## **Proposal for Supplement 12 to the original version of Regulation No. 99 (Gas-discharge light sources)**

### **Submitted by the Working Party on Lighting and Light-Signalling\***

## **Supplement 12 to the original version of Regulation No. 99 (Gas-discharge light sources)**

"10. Colour

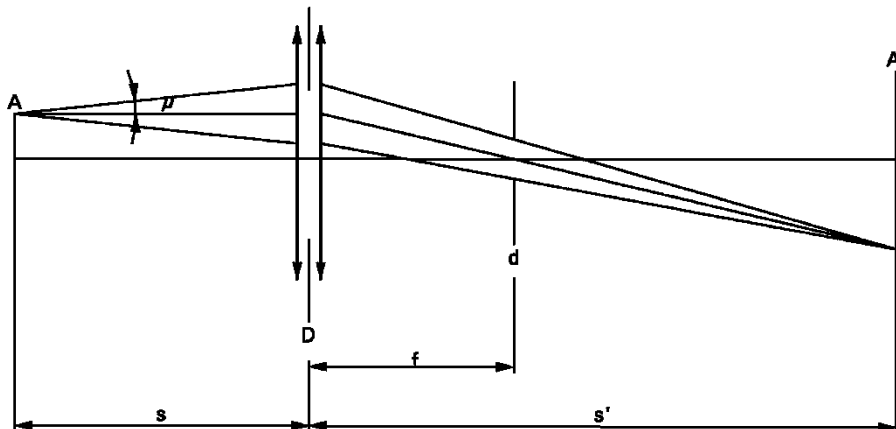
*Paragraph 10., delete the figure and amend to read:*

The colour of the light source shall be measured in an integrating sphere using a measuring system which shows the CIE chromaticity co-ordinates of the received light with a resolution of  $\pm 0.002$ ."
